REMARKS

Appln. No. 10/760,655
Amendment dated August 27, 2004
Reply to the Office Action of June 30, 2004

FIG. 16

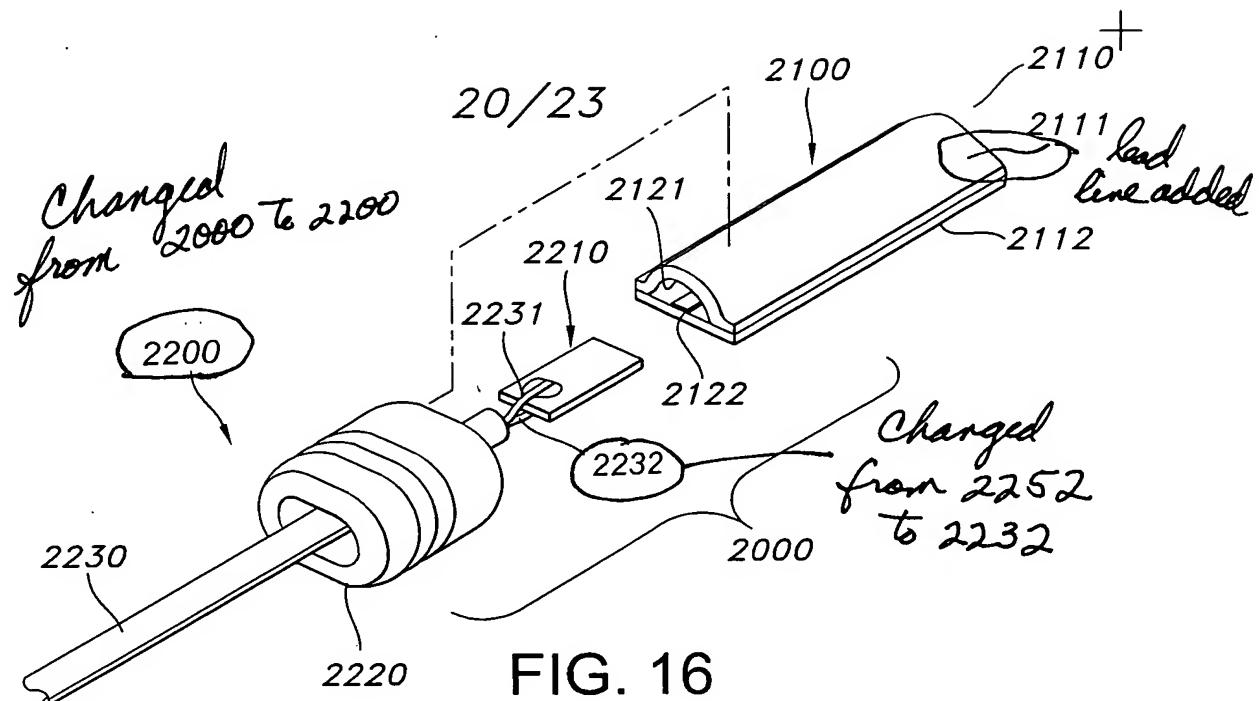
The drawings are objected to. In particular, regarding FIG. 16, element 2111 was not connected to any feature, and there were two numerals 2000. At page 44, line 13 of the specification element 2200 was not shown in the drawings. These informalities have been addressed by adding a lead line to numeral 2111 showing the feature to which it is connected, and changing one of the numerals 2000 to 2200.

In FIG. 16 element 2252 has been changed to 2232. The connected feature is a wire lead as identified at page 45 line 14 of the specification as 2232.

FIG. 17A

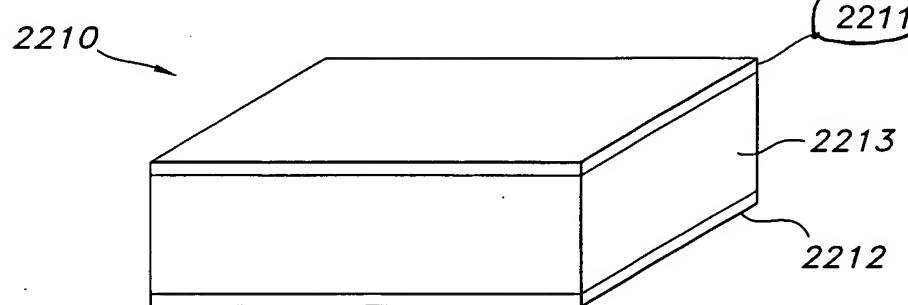
In FIG. 17A the conductive contact electrode 2211 (see, page 44, lines 14-18 of the specification) had been erroneously numbered as 2210. This is corrected by amendment herein.

Changed from
2210 &
2211

FIG. 19

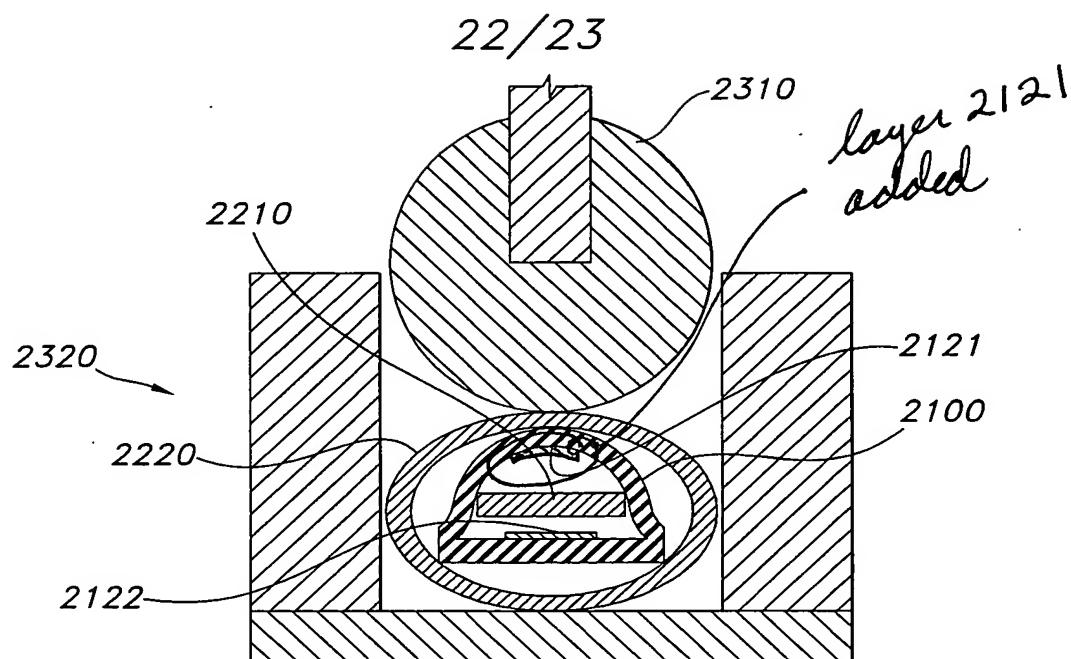
In FIG. 19, the feature to which numeral 2121 is connected, i.e., a conductive electrode film, is added by amendment.
